Town of Medway
DESIGN REVIEW COMMITTEE
155 Village Street, Medway MA 02053
(508) 533-3291

DRC Meeting Minutes: December 16, 2019
Medway Public Library

approx. 1123 SF

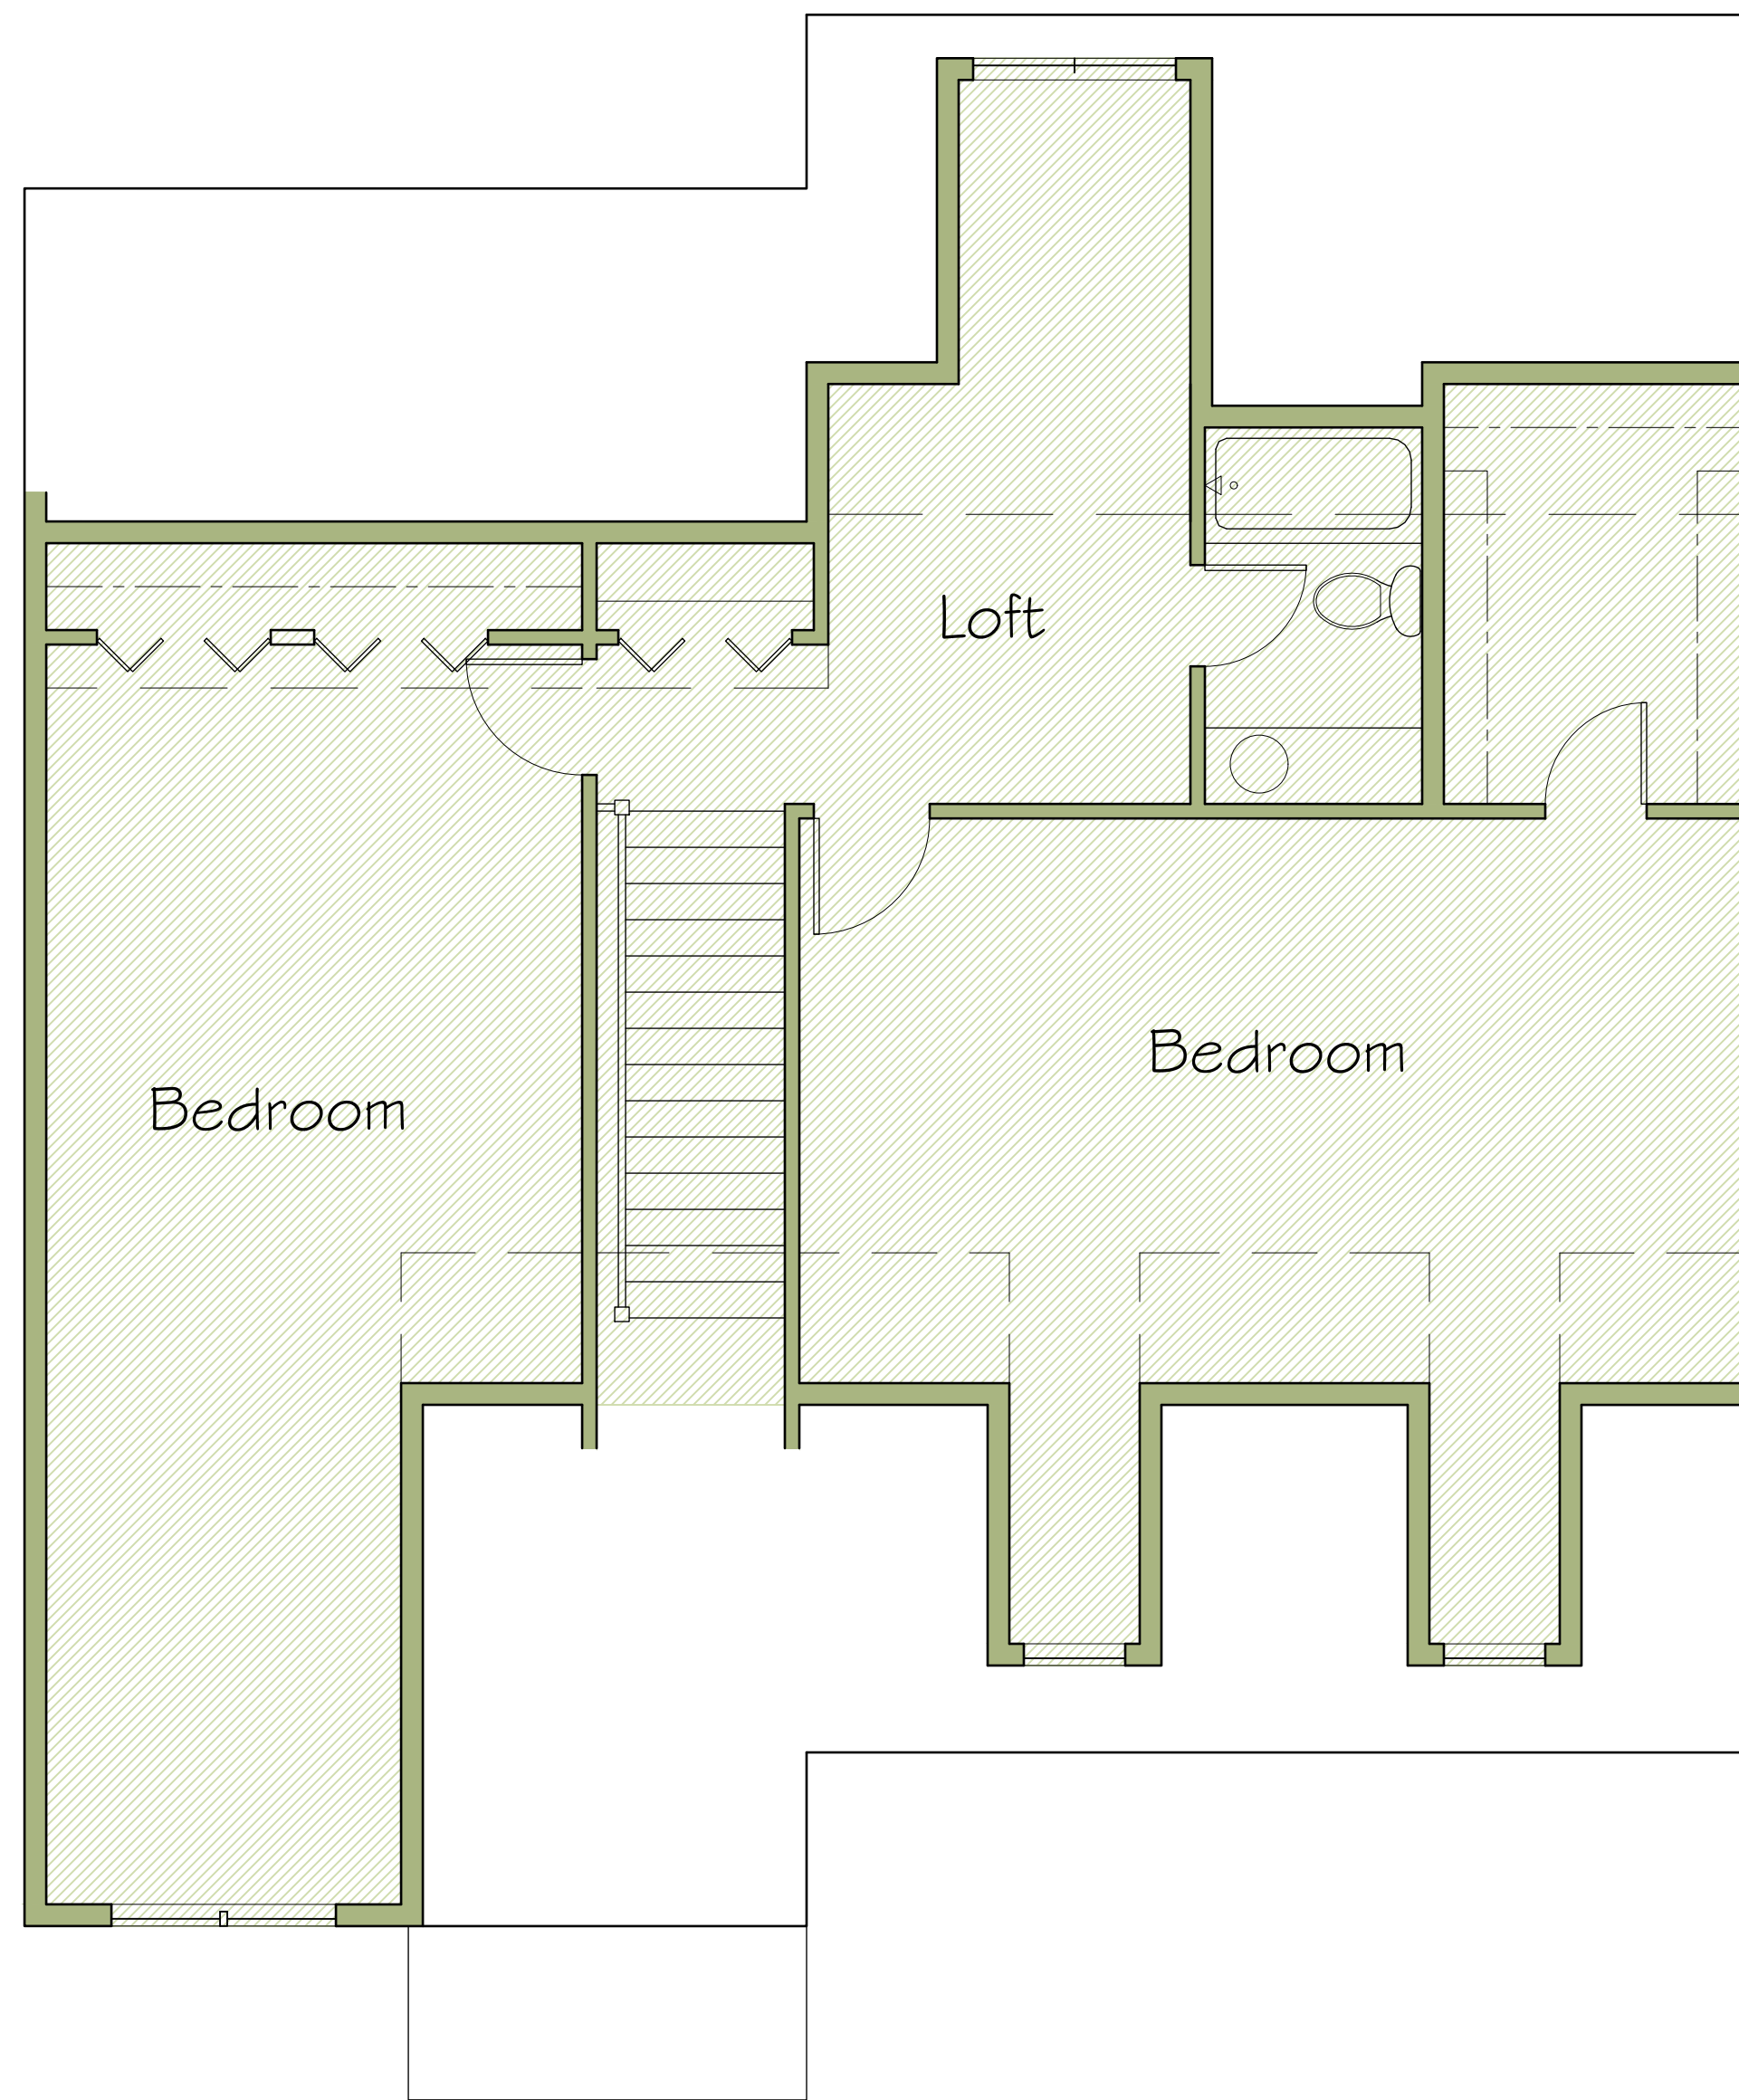
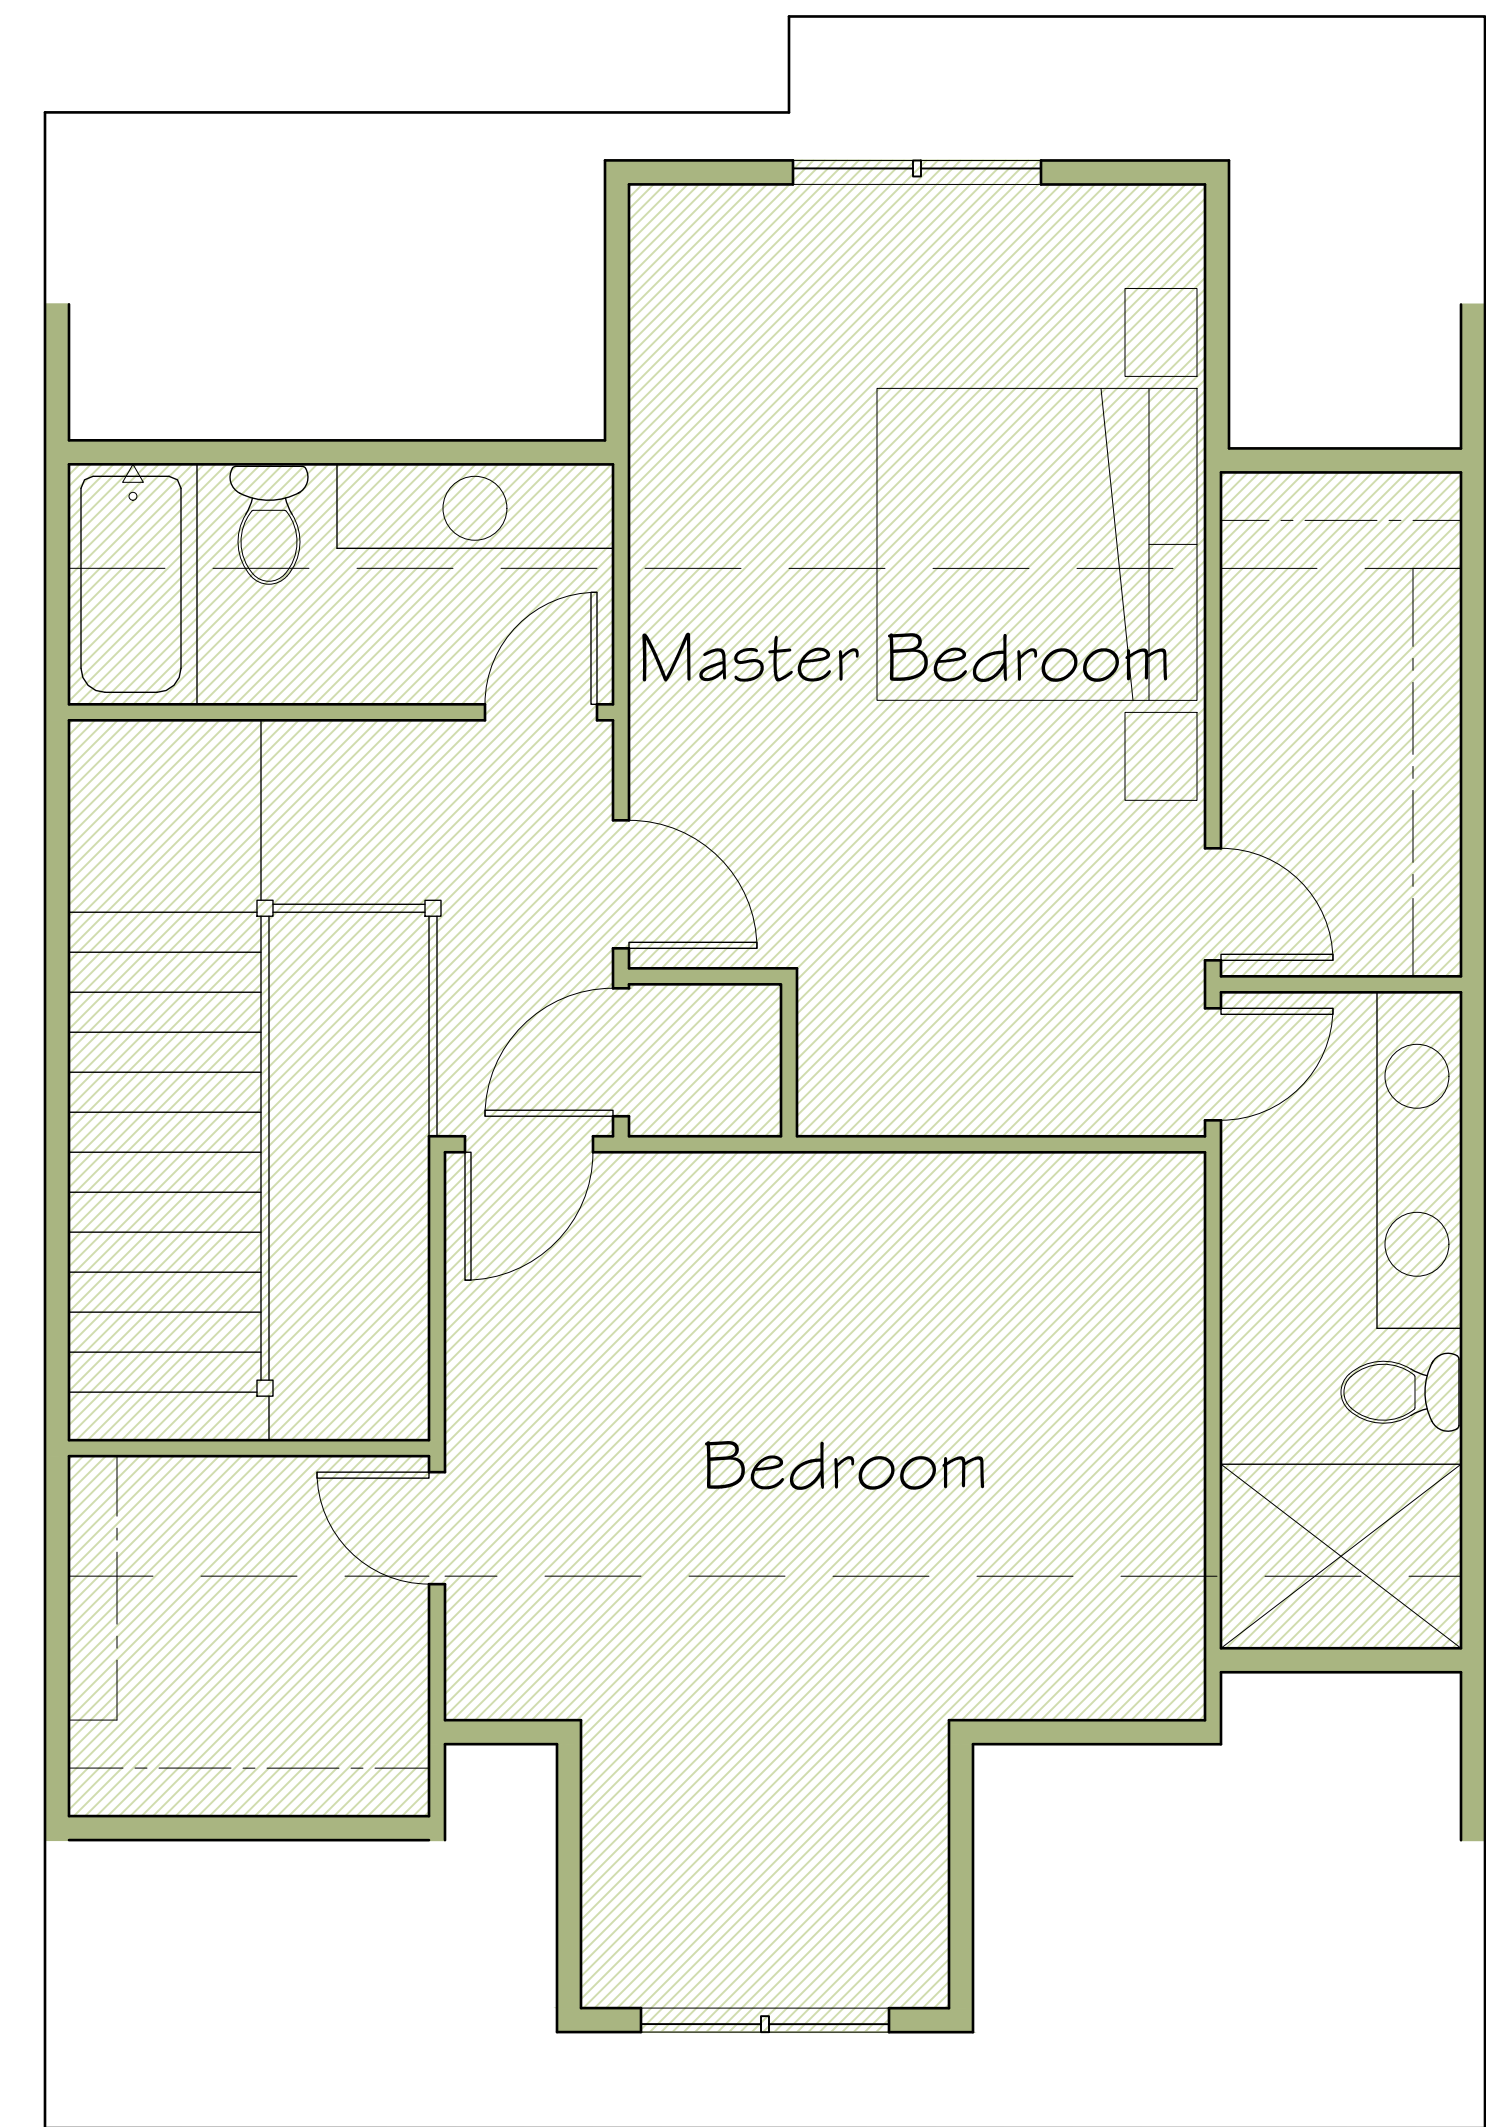
- Ms. Varrichione attended the meeting to discuss the item. The revised plan was submitted to the committee. **(See Attached)**
- Members liked the shingle details with the shown dimensions to the roof line. Dark charcoal grey siding will be used. The fence will be installed on the west side of the property and will go past the end unit in the back.
- The project will be presented at the Planning Board meeting on January 28th and at CONCOM on January 9th. Ms. Chabot will prepare the DRC's review letter.

Here they are per the DRB requests except for one thing. They had asked for one of the units in the four unit building to be flipped, but when I looked at it further, it didn't make sense. If unit 4 is the unit towards the street, when you flip unit 6, there are still garage doors beside each other. The front doors are all separated from each other either way. But when I looked at the site plan, the original configuration is best. First of all, I'd rather have the garage doors on the high side where possible. The grading is better that way, Whenever the garage doors are on the low side, the grade has to drop more suddenly at the adjacent unit. Plus, the garage doors that are side by side are offset, front to back, and if I flip Unit 6, the garage doors almost align.

As mentioned, I did not change the column size on the color rendering, but I have changed them on the black and white. Please let me know if you need anything else.

DRAWING TITLE:
PROPOSED ELEVATIONS

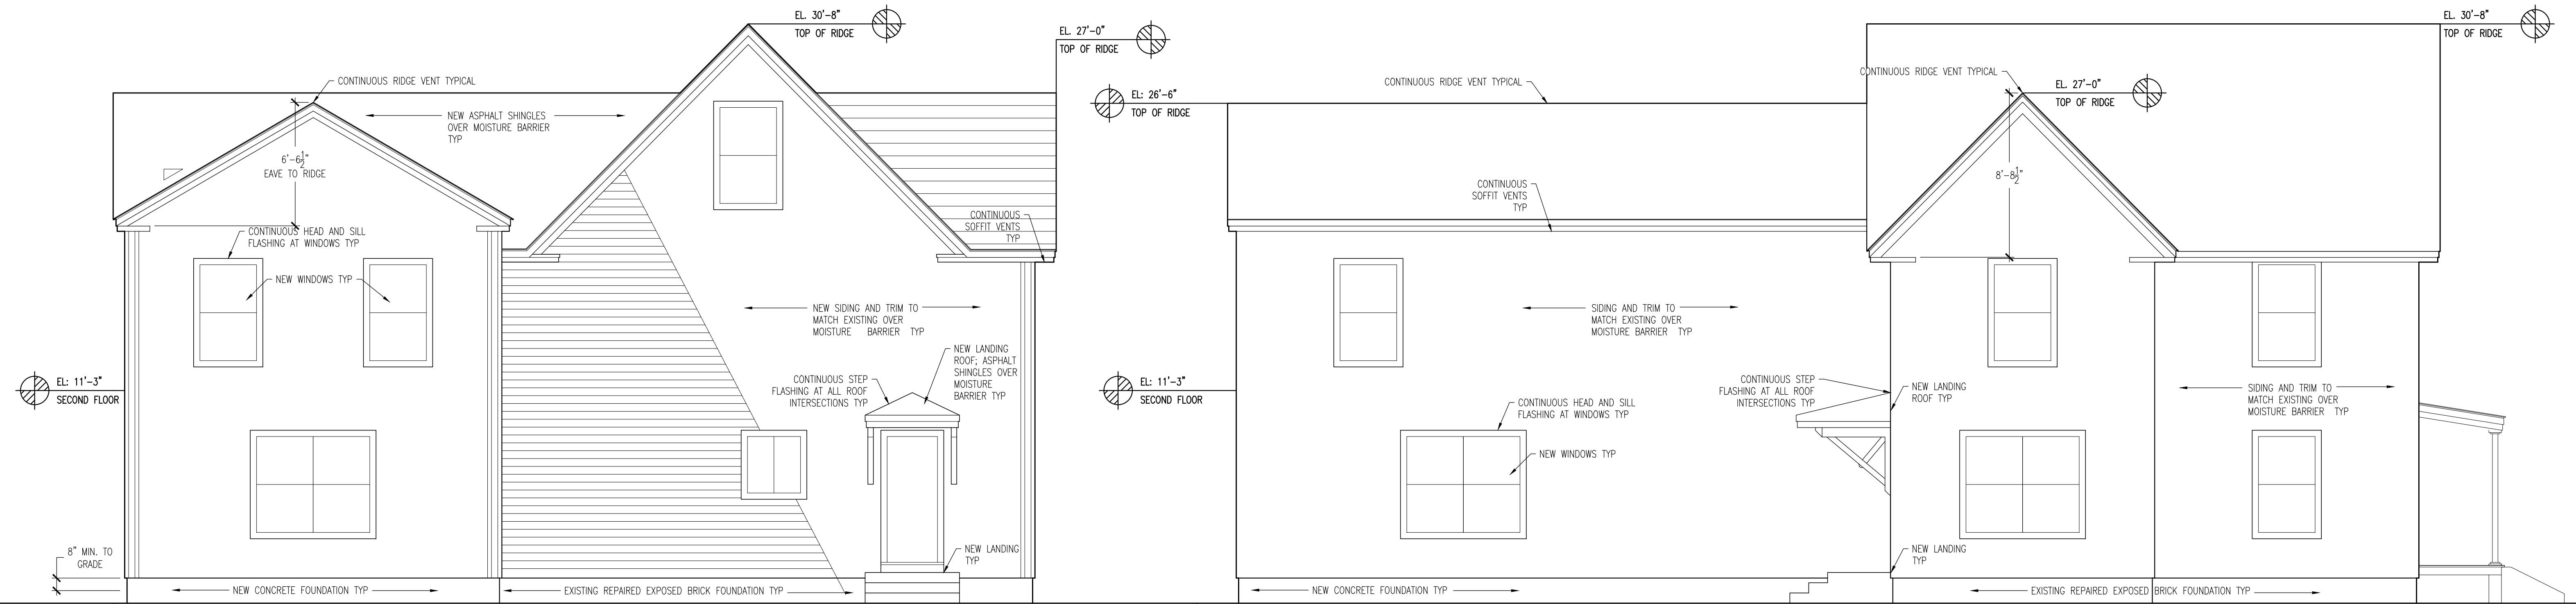
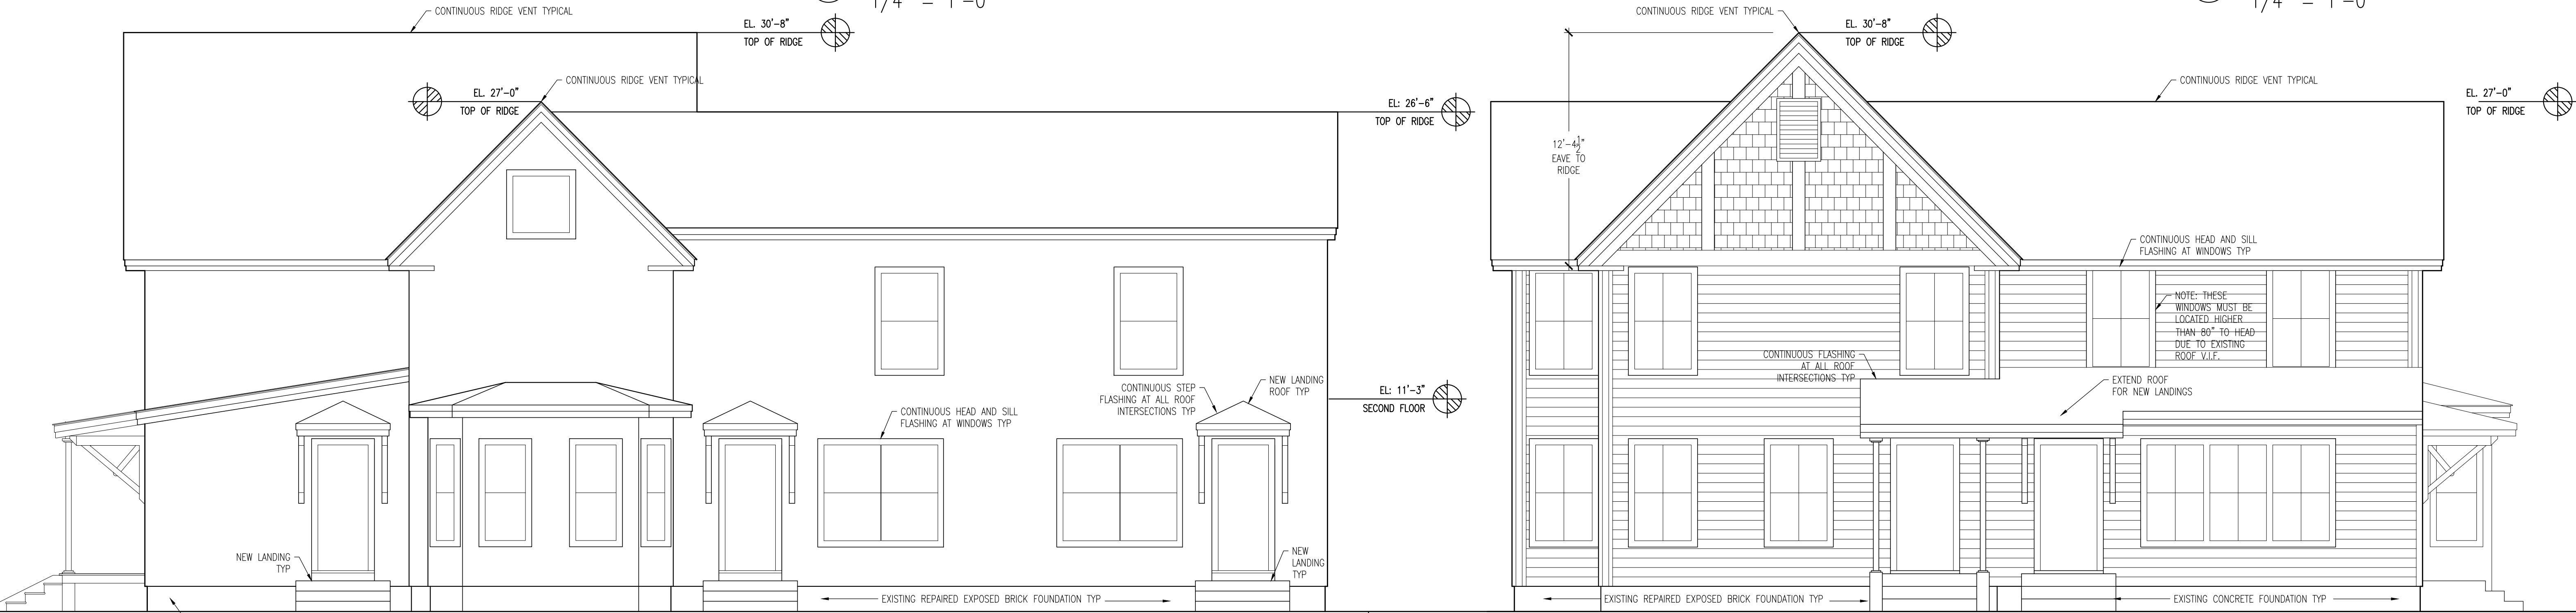
- Mr. Thibault, architect, Mr. Brody, and Mr. Collins attended the meeting to discuss the item. Based on the feedback provided at the last meeting, a number of architectural changes have been made to the proposal. **(See Attached.)**
- Lack of cohesion between the existing and proposed buildings was a comment made at the last meeting. Porch roofs to the side entries have been added. The two buildings share a similar color palette. Predominant color of the houses is white as is the case with most of the houses in Medway. Vinyl siding for the unit is proposed. Members asked for the shingle colors to be shared with them.
- Ms. Chabot commented on moving the attic vent lower than where it's shown on the rendering.
- There will be vinyl fence surrounding the dumpster that's located in the back.
- Applicant said landscaping plan is available and will be made available for the DRC's review.
